COUNCIL ASSESSMENT REPORT

| DA Number | 393/22 |
| Proposed Development | Demolition of existing buildings on-site and the construction of a 43-storey commercial tower |
| Street Address | 153-157 Walker Street, North Sydney |

Illustrations indicatively comparing a DCP-compliant envelope (left) with that proposed (right), on Walker Street (above) and Little Walker Street (below).

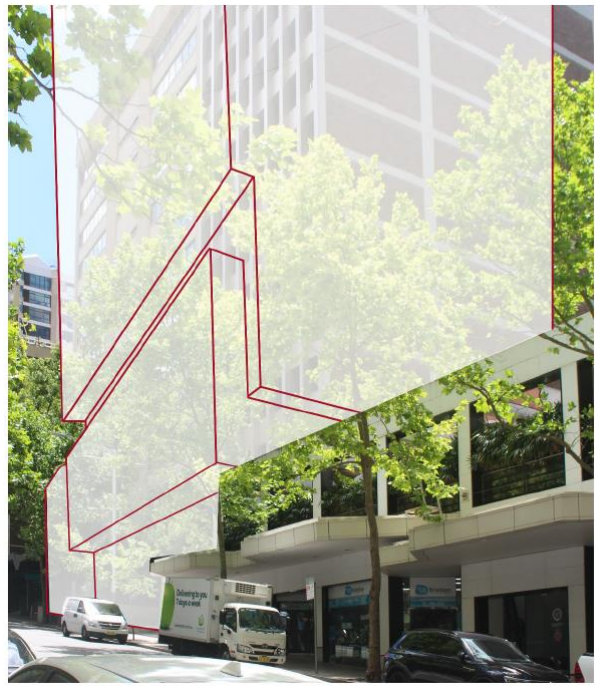
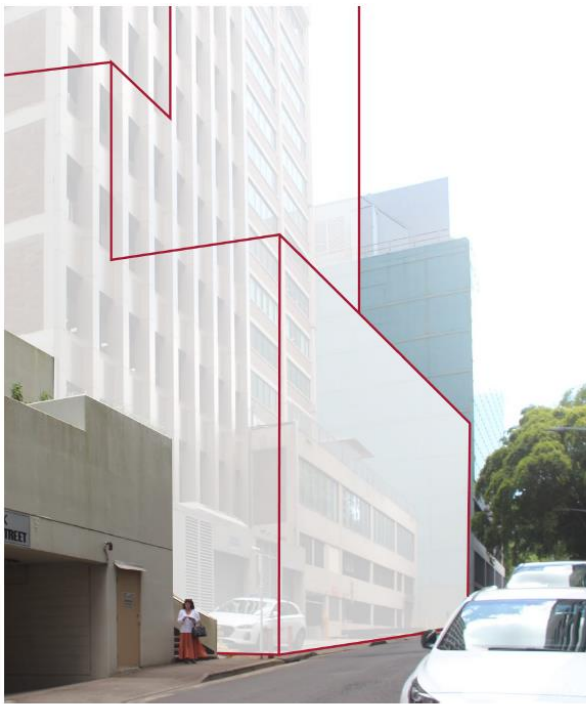
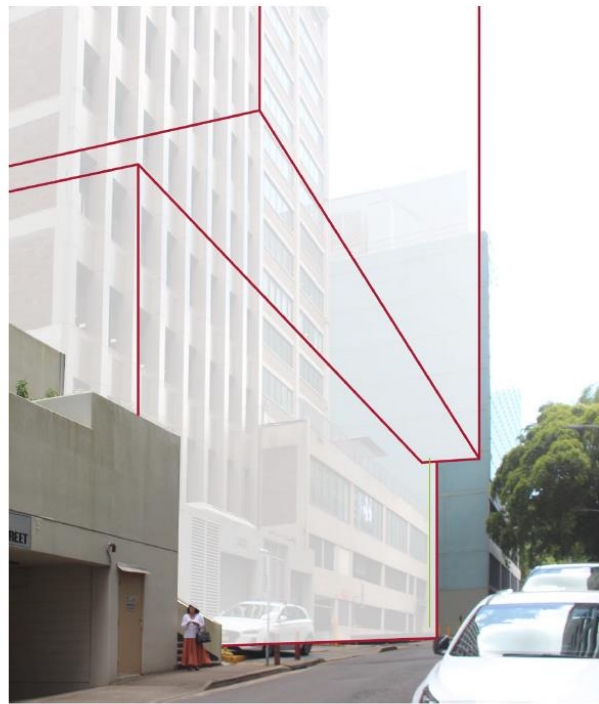
Comment: *The images provided with the application discussed below indicate the opposite, the proposal is readily interpreted as being taller, wider and deeper – bulkier - than a compliant envelope.*

Ground Floor - Walker St showing 4.3m setback (red line shows retail activated frontage)

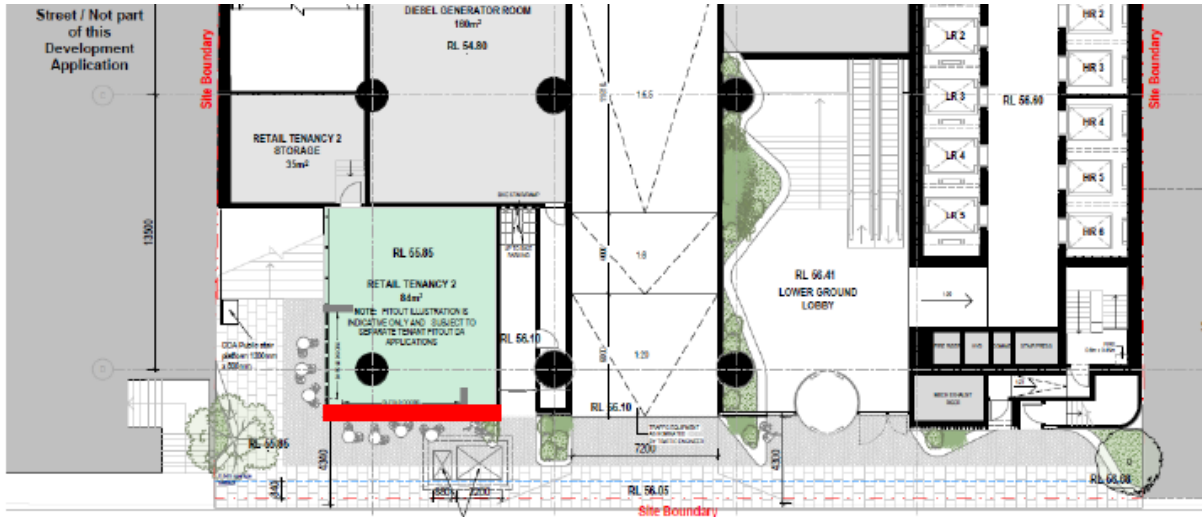
The NSDCP 2013 requires a zero setback to all street frontages at the ground level, unless otherwise stated. The proposal incorporates a 4.3m ground floor setback to Walker Street to 'expand the public domain' and a 4m lower ground floor setback to Little Walker Street to enhance the 'almost non-existent pedestrian pathway.'

- The recess in the podium along Walker Street deviates from the established street pattern and rhythm, which disrupts the overall coherence of the surrounding architectural context. Moreover, the inverted podium design along Little Walker Street, coupled with its lack of above podium setback, intensifies the "canyoning effect" of the street. This creates a narrow and enclosed feeling that diminishes the open and pedestrian-priority nature envisaged for Little Walker Street in the Public Domain Strategy. Furthermore, this configuration results in a loss of human scale, as the building's massing dominates the surrounding streetscape, detracting from the desired pedestrian experience.

It is recommended that the podium form to Walker Street is built to the boundary and a non-inverted podium form typology be adopted to Little Walker Street, to comply with the NSDCP 2013.

Figure 12: View from Walker Street, the compliant envelope is to the left and the proposed building to the right. The compliant form leaves a clear gap between it and the adjacent building, the proposed envelope almost closes this gap (Ethos Urban).

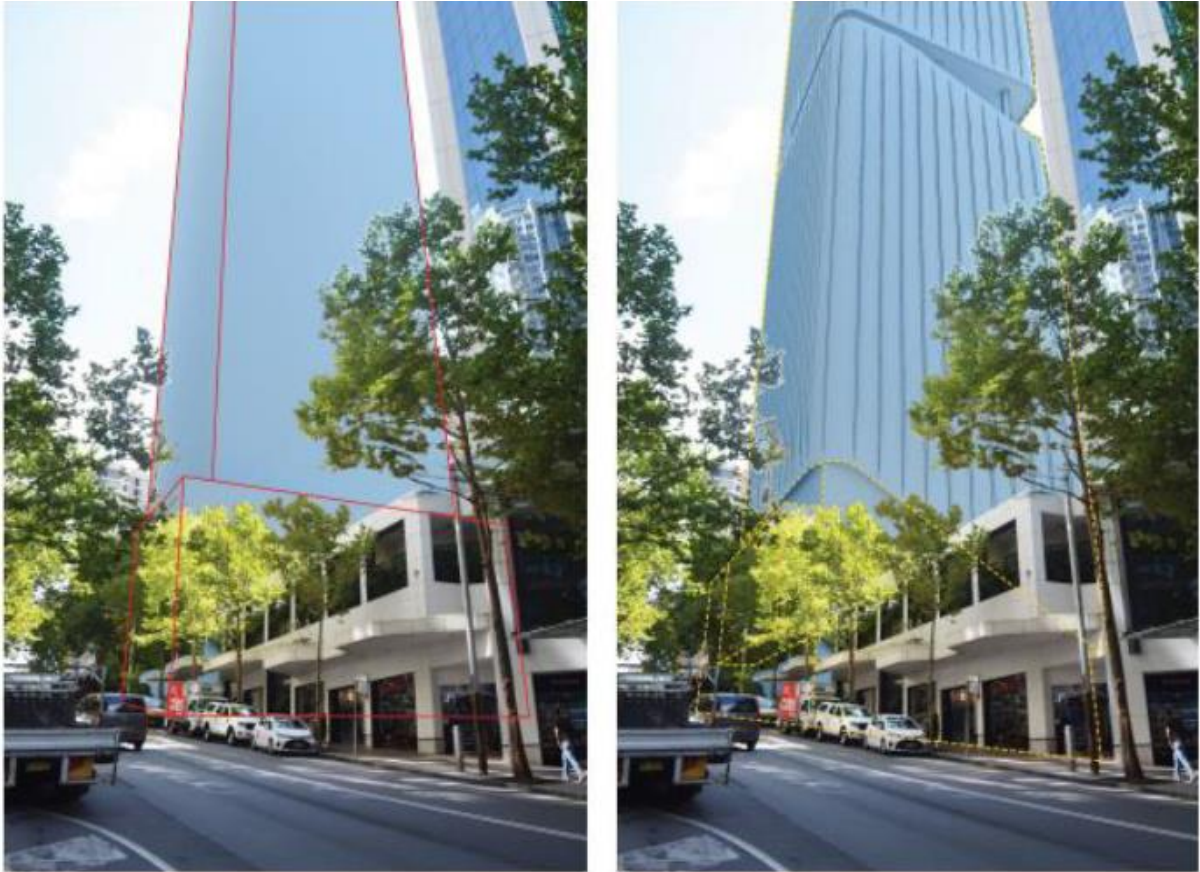
In the preceding table it is noted that the proposal would have an acceptable impact on the views of the North Sydney CBD if the building were to comply with tower setbacks and height. As shown in the montages below, the compliant envelope is appreciably less bulky and would provide for adequate separation between buildings, especially when land either side of the site is redeveloped.

Ensuring adequate setbacks and building separation is vital to maintaining space for daylight penetration into the public domain and buildings, and to promote a safe and comfortable microclimate. Of equal importance is the appearance of the building, as it would be highly visible due to its location, permitted (and proposed) height, and potential building heights around it to the east and north being substantially lower.

As the tower element of any building on this site would be highly visible, any building should be less visually dominant than the proposal, achievable via compliance with setbacks and height controls, complemented by judicious use of materials, finishes and colours.
